# Access Compliance Report

## Public Rights-of-Way

Intersection ID: 22192	Main Street: MOORELAND_FARMS_RD	Cross Street: CARMEL_RD	Location: S
ADA ID: 69DB81EE38DF	Ramp Type: PerpDiag	Initial Pass/Fail: Fail	Overall Compliance: No
Severity Score: 13.75			
Codes/Mitigation Info/Possible Solution		Field Measurements/Component Compliance

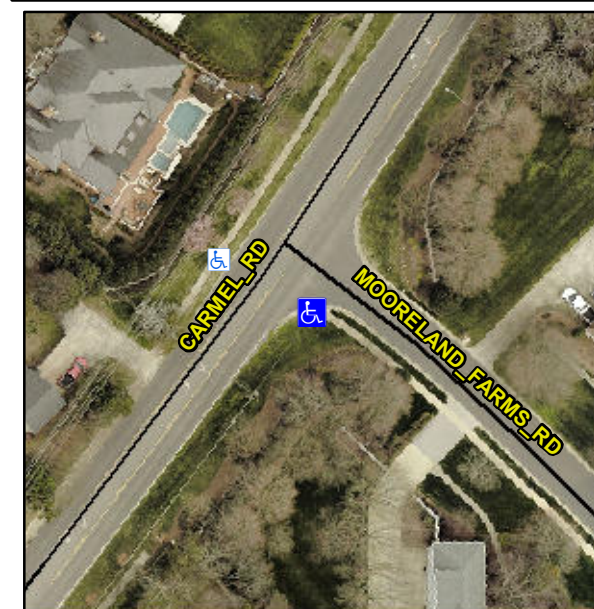
**Not Found, R304.2.2, R304.5.3**

Compliance	Description	Data	Compliance	Description	Data
N/A	Ramp Length (in)	48.0	No	Ramp Slope (%)	9.1
Yes	Ramp Width (in)	48.0	No	Ramp XSlope (%)	3.3
N/A	Flare Type LT	N/A	N/A	Flare Type RT	N/A
N/A	Flare Slope LT (%)	N/A	N/A	Flare Slope RT (%)	N/A
N/A	Flare Traversable LT?	N/A	N/A	Flare Traversable RT?	N/A
N/A	Landing Length (in)	N/A	N/A	DWS Provided?	N/A
N/A	Landing Width (in)	N/A	N/A	DWS Contrast?	N/A
N/A	Landing Slope (%)	N/A	N/A	DWS Length (in)	N/A
N/A	Landing X Slope (%)	N/A	N/A	DWS Full Width?	N/A
N/A	Landing Curb? (Y/N)	N/A	N/A	DWS Offset (in)	N/A
N/A	Shared Landing?	N/A			
N/A	Gutter Ponding?	N/A	N/A	Gutter Slope (%)	N/A
N/A	Gutter Lip Ht (in)	N/A	N/A	Gutter X Slope (%)	N/A
N/A	Painted X Walk1?	No	N/A	Painted X Walk2?	No
	X Walk 1 Direction	To NE		X Walk 2 Direction	To NW
N/A	X Walk 1 Width (in)	N/A	N/A	X Walk 2 Width (in)	N/A
	X Walk 1 Slope (%)	1.2		X Walk 2 Slope (%)	4.3
	X Walk 1 X Slope (%)	3.5		X Walk 2 X Slope (%)	1.9

**Remove & Replace Curb Ramp With Two New Directional Ramps or Equivalent.**
